Enclosure to
ULNRC-06818

**Response to Request for Additional Information
Regarding License Amendment Request
For Permanent Extension of Type A and Type C
Leak Rate Test Frequencies**

RESPONSE TO
REQUEST FOR ADDITIONAL INFORMATION REGARDING
LICENSE AMENDMENT REQUEST FOR
PERMANENT EXTENSION OF TYPE A AND TYPE C LEAK RATE TEST FREQUENCIES

DETAIL (6)
 SCALE 3" = 1'-0" C-2L2908

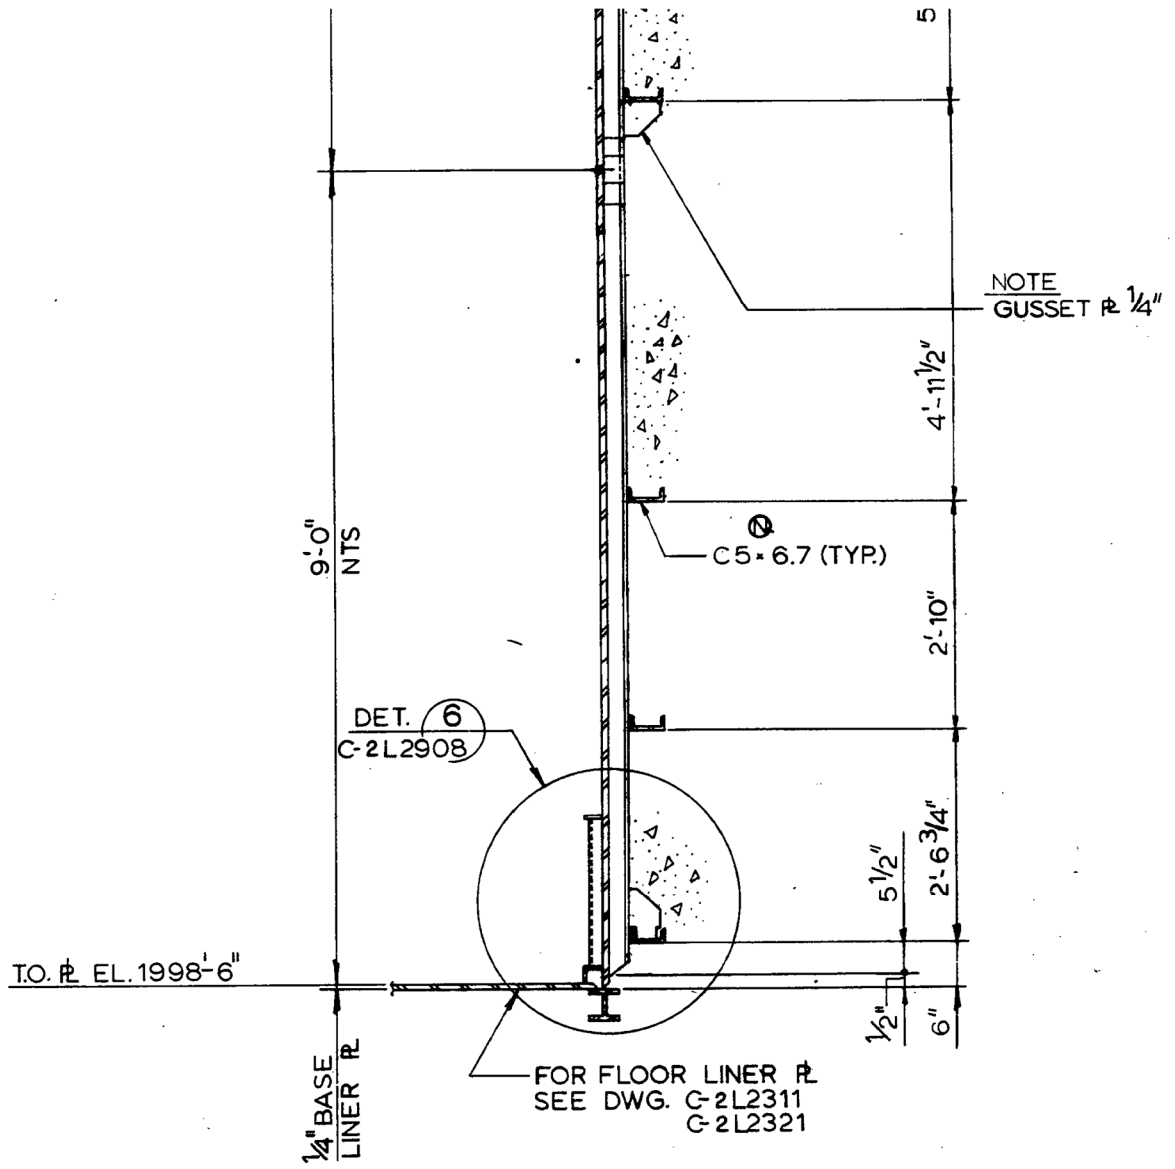
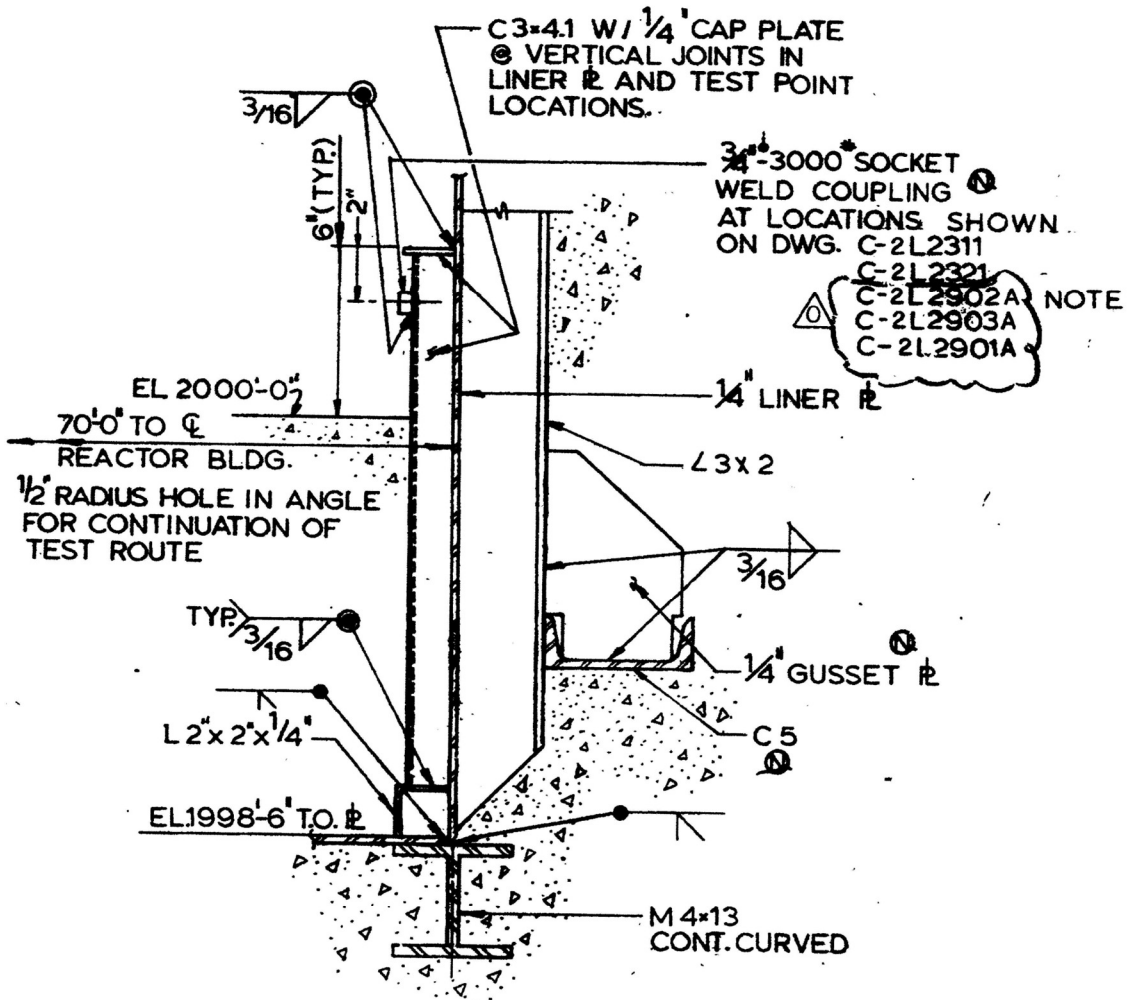
Regarding the interface between the installed concrete fill slab and the vertical liner plate on the containment wall, it is not clear how moisture intrusion into inaccessible areas of the pressure retaining containment liner under the slab will be prevented without some type of moisture barrier material.

Describe the interface design at the installed concrete fill slab directly against the vertical liner plate on the containment wall and describe any features that prevent intrusion of moisture into inaccessible areas of the pressure retaining metal containment liner under the slab.

The interface design is shown on the following excerpts from Reactor Building Liner Plate and Wall Detail drawings:

TYPICAL LEAK CHASE ADJACENT TO WALL

Any moisture introduced to the containment concrete floor to steel liner interface at the 2000' elevation, a possible location for water intrusion, would be conveyed away from the liner as the floor is sloped at all points around containment away from the steel liner. Also, no cracks or openings between the concrete floor and steel liner have been identified.

The steel liner to concrete floor interface is also inspected every 18 months (every refuel) under the Coatings Aging Management Program and every 4.5 years (every 3 refuels) under the Structural Monitoring Aging Management Program. The inspection under the Structural Monitoring Aging Management Program was completed in RF20 with no identified issues related to Information Notice 2014-07, "Degradation of Leak Chase Channel Systems for Floor Welds of Metal Containment Shell and Concrete Containment Metallic Liner."
